# **Pentium® II Processor Specification Update**

Release Date: January 1998

Order Number: 243337-009

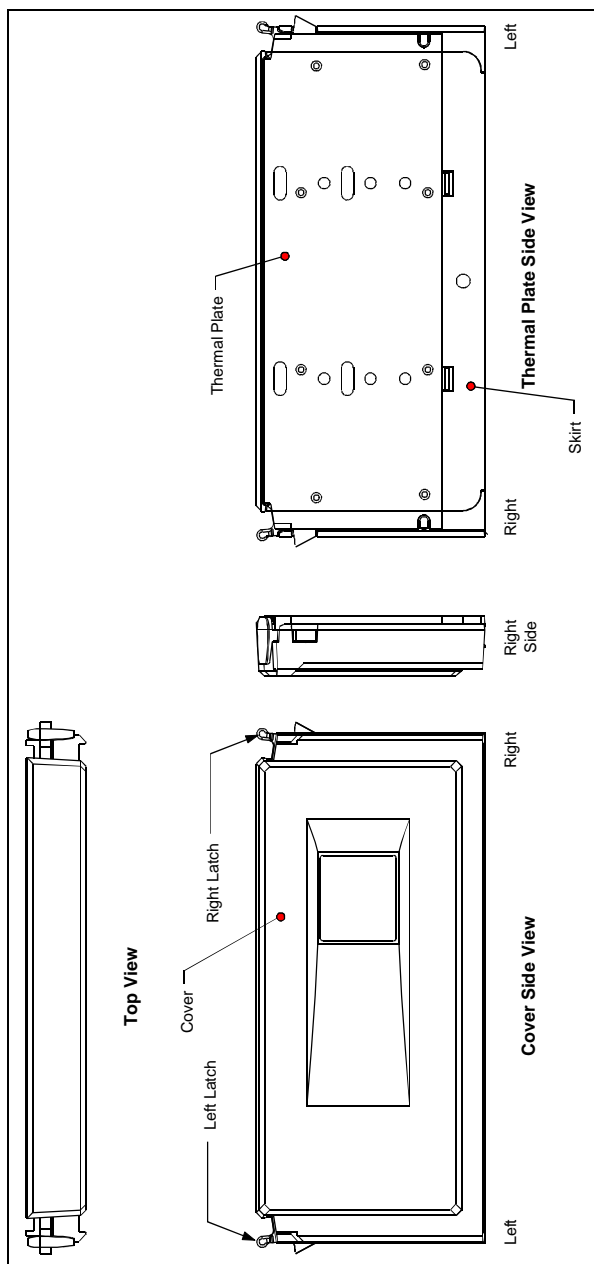
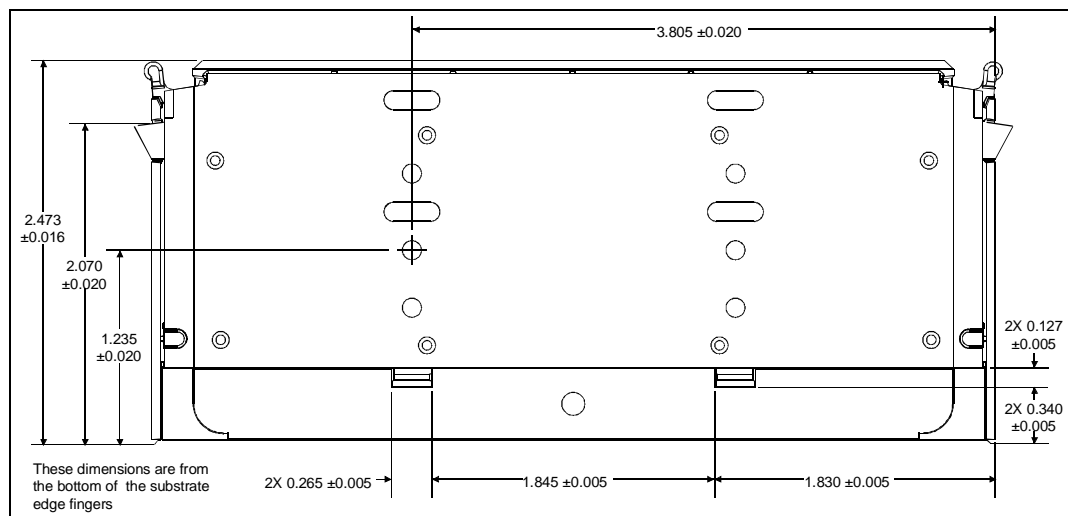
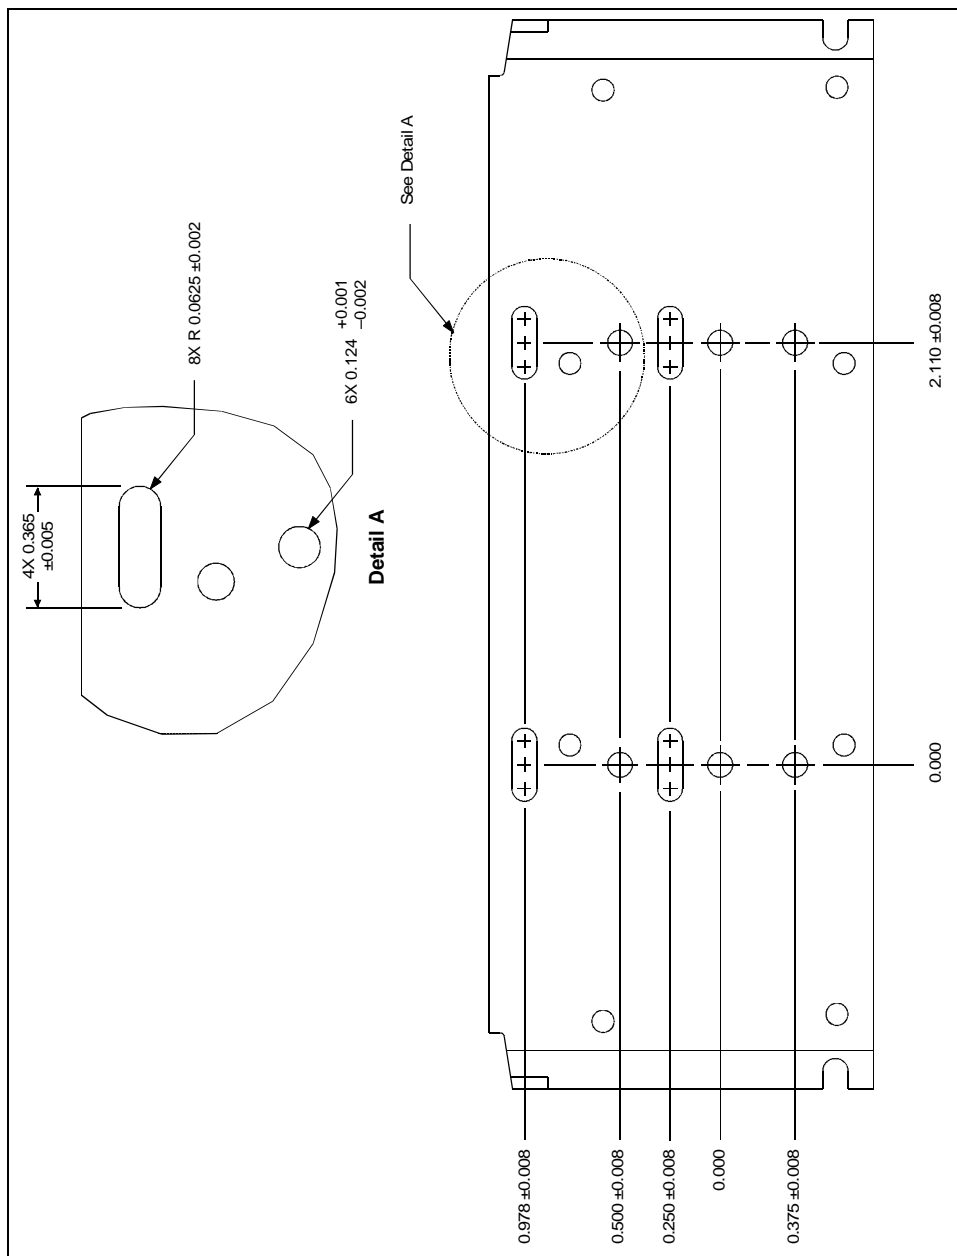
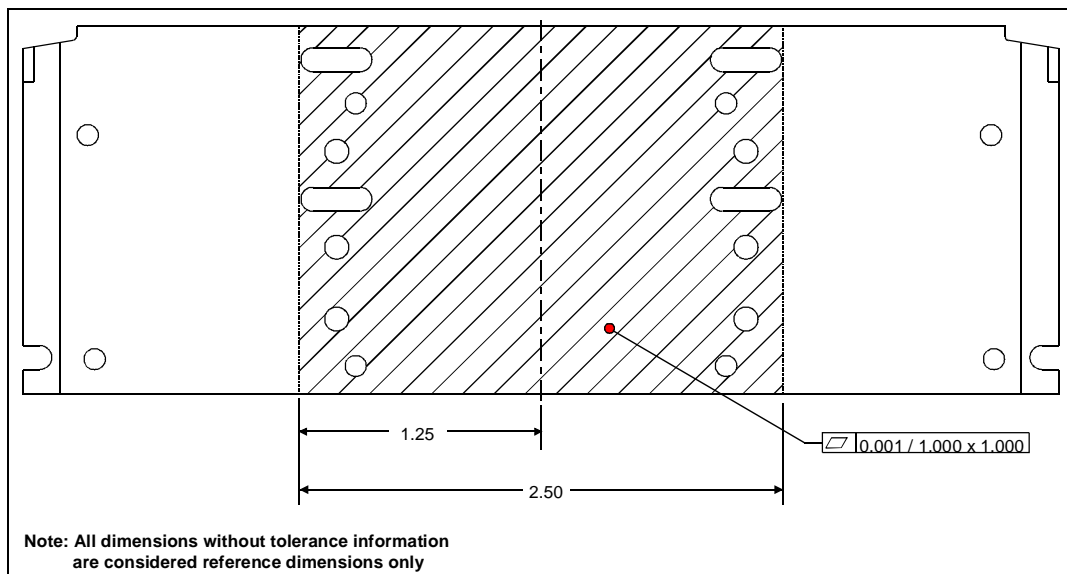
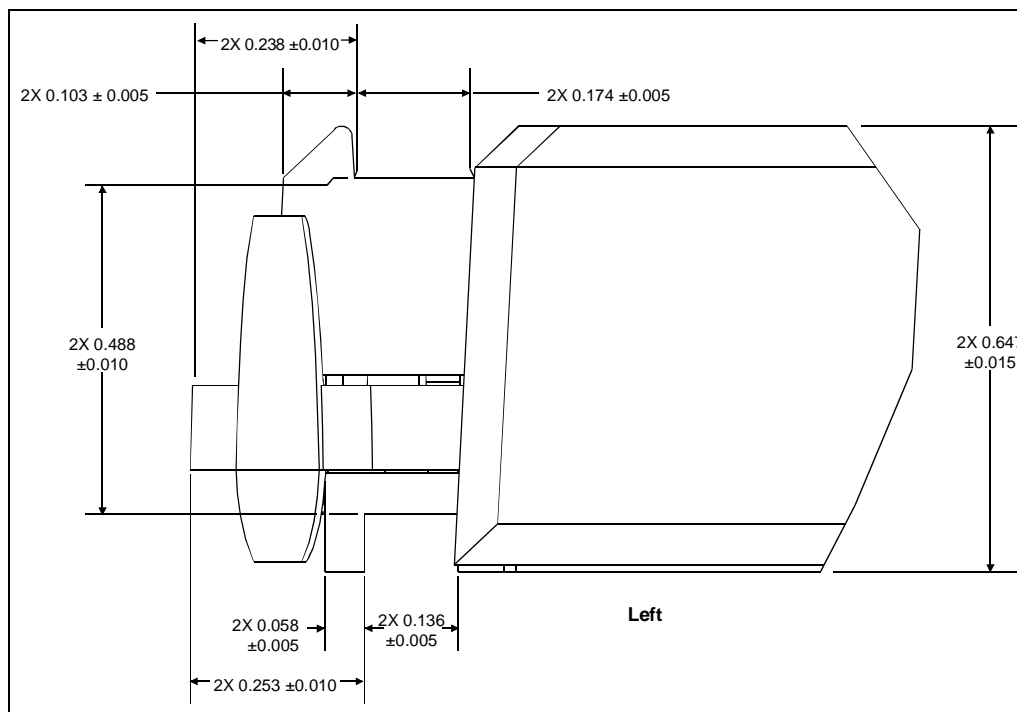
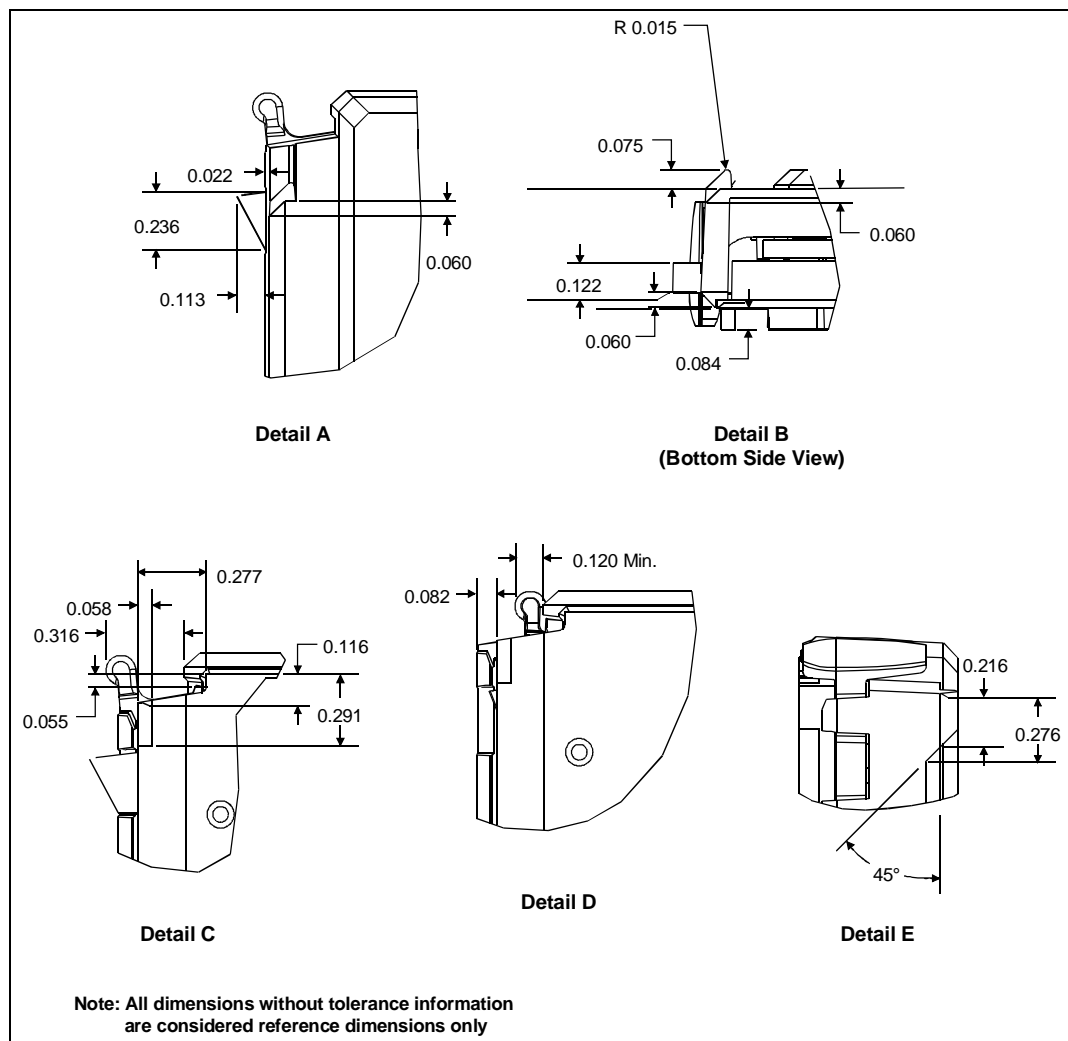
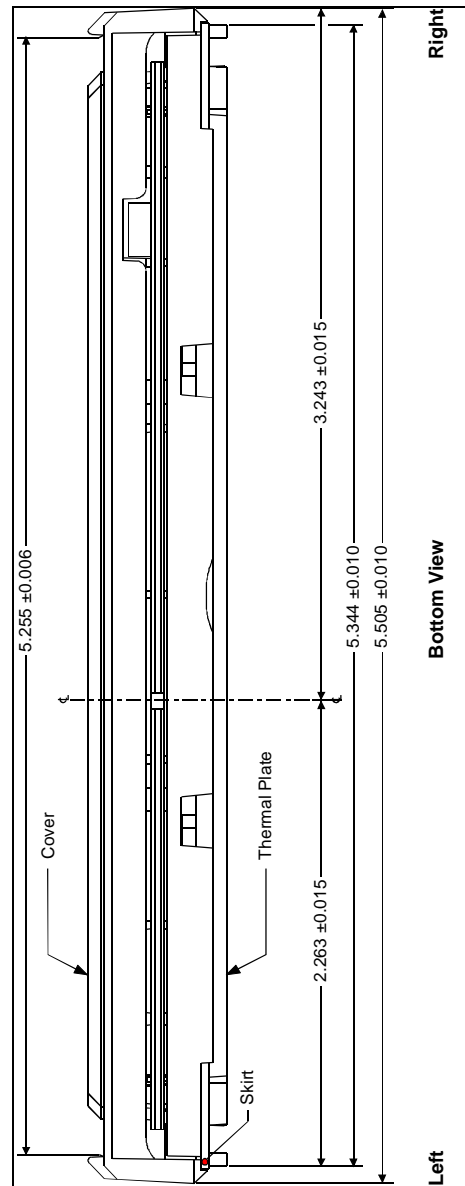
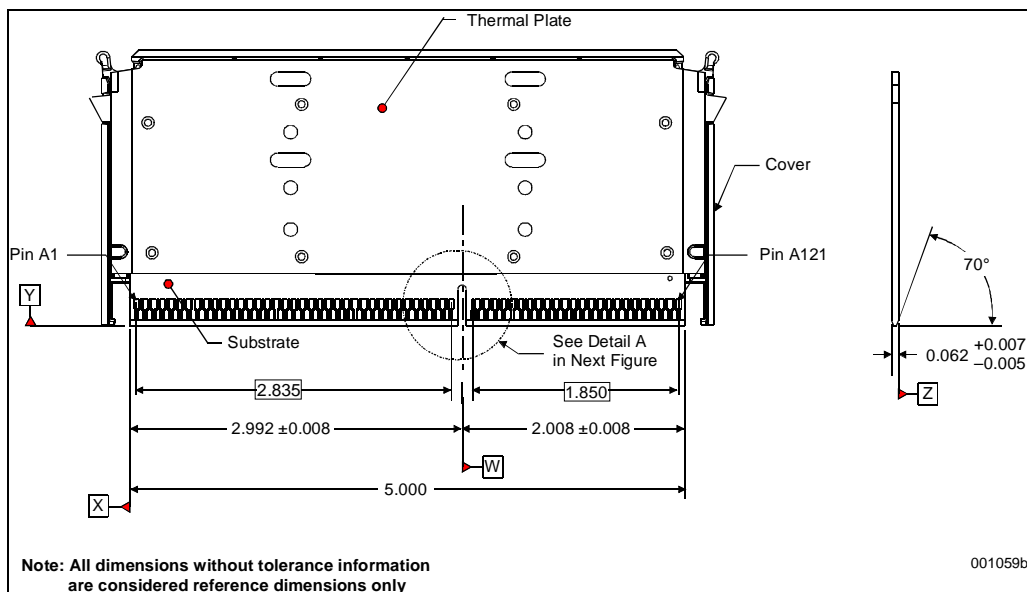
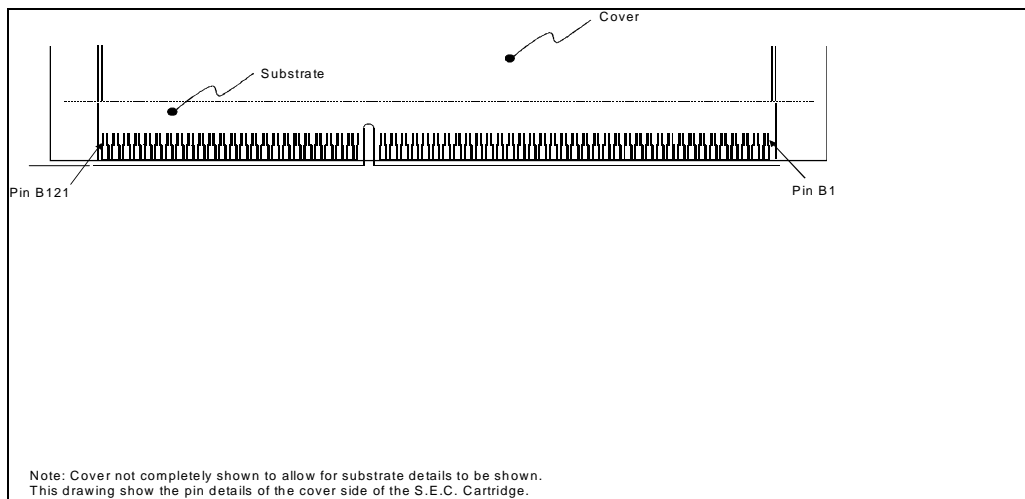
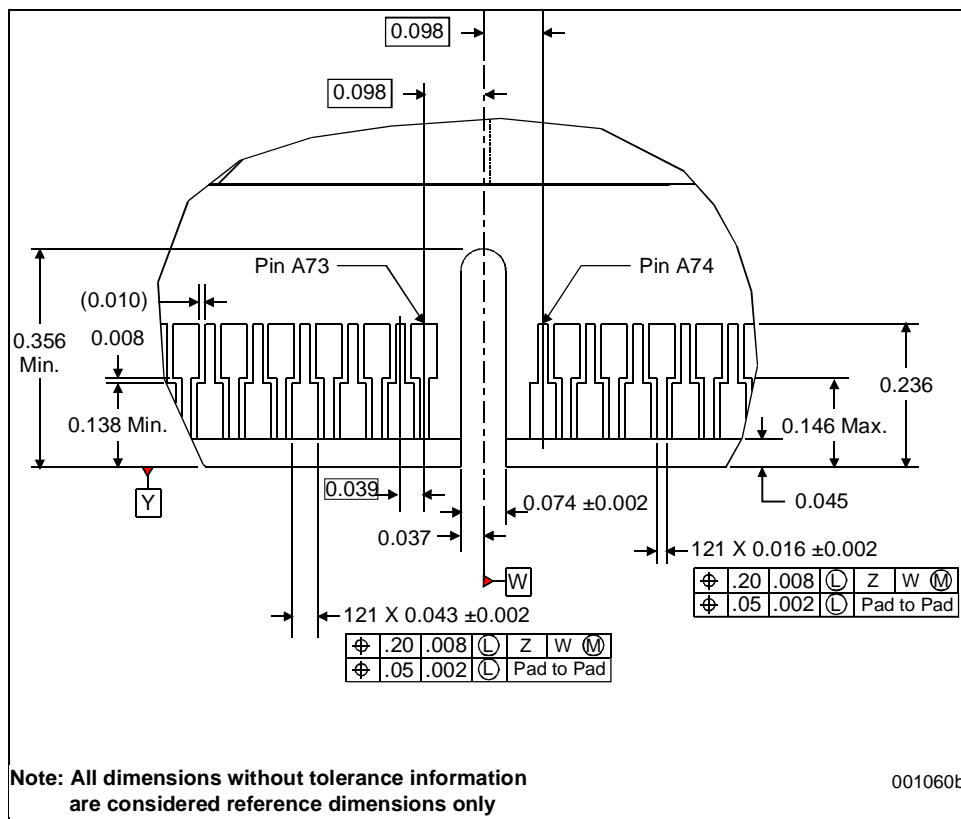
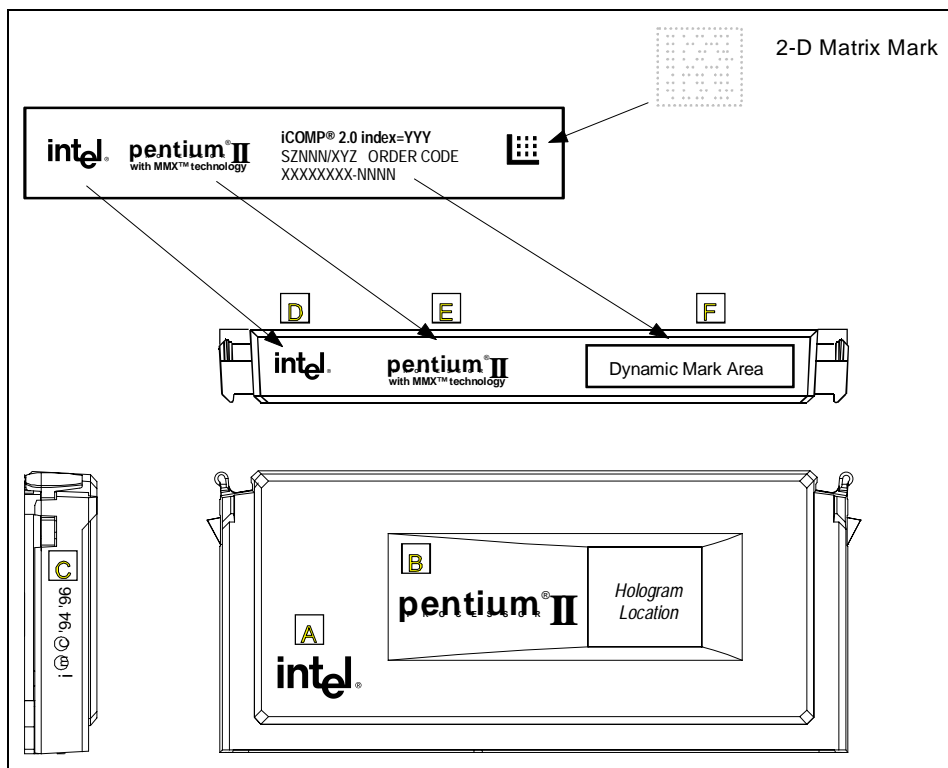
The S.E.C. cartridge mechanical specifications provided in the *Pentium® II Processor at 233 MHz, 266 MHz and 300 MHz* datasheet contained incorrect tolerance information for some dimensions. Also, some of the information provided in the figures was duplicitous and not required to accurately use and design for the S.E.C. cartridge package. The revised figures provided in this section are meant to replace Figures 29 through 42, Table 23 and the accompanying notes found on page 44.

**Figure 12. Heatsink Attachment Mechanism Design Space**

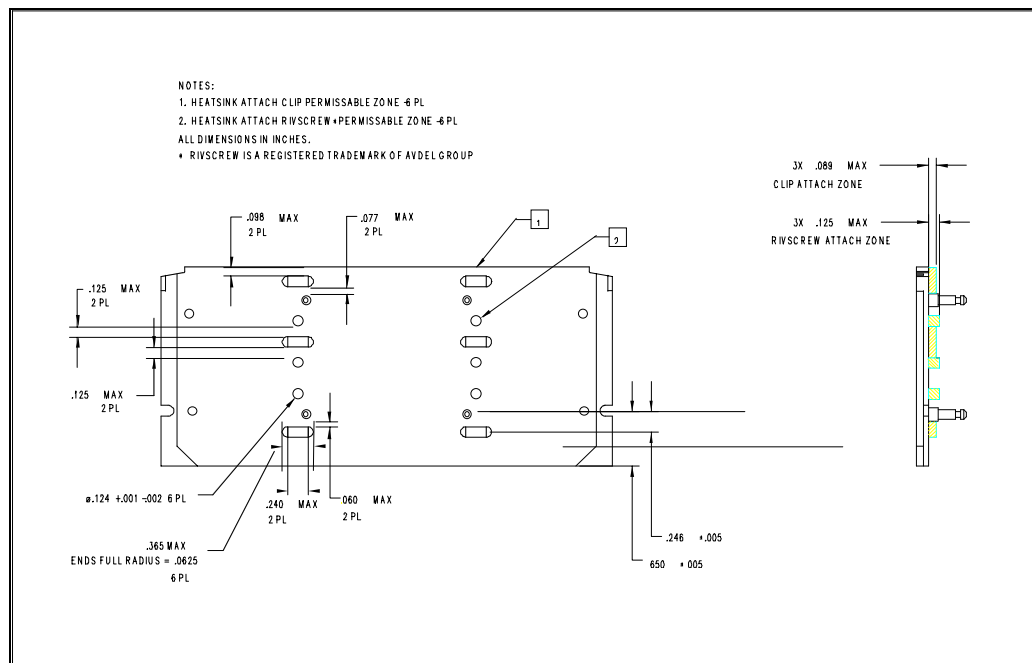
A change to the attach mechanism specification is provided below. The original specification for clearance of heatsink attach solutions is provided in Section 4.3 (and Figure 23 and Figure 24) in the *Pentium® II Processor at 233 MHz, 266 MHz and 300 MHz* datasheet. Figure 11 shows the revised maximum specifications for heatsink clip and RivscREW® attach mechanism designs. All heatsink clip and RivscREW attachment solutions must remain within the respective maximum “permissible” zone as detailed in Figure 11.

The thermal plate shown in Figure 11 is used to portray the heatsink attach mechanism design space for the future Slot 1 processors. However, the maximum “permissible” design space is also valid for both the current Pentium II and future Slot 1 processors.

Please review the proposed specifications to guarantee compatibility with existing Pentium II and future Slot 1 processor heatsink attachment solutions. Note that the required heatsink attachment solution space should not exceed the maximum proposed design space while installed or during the installation and removal procedure.
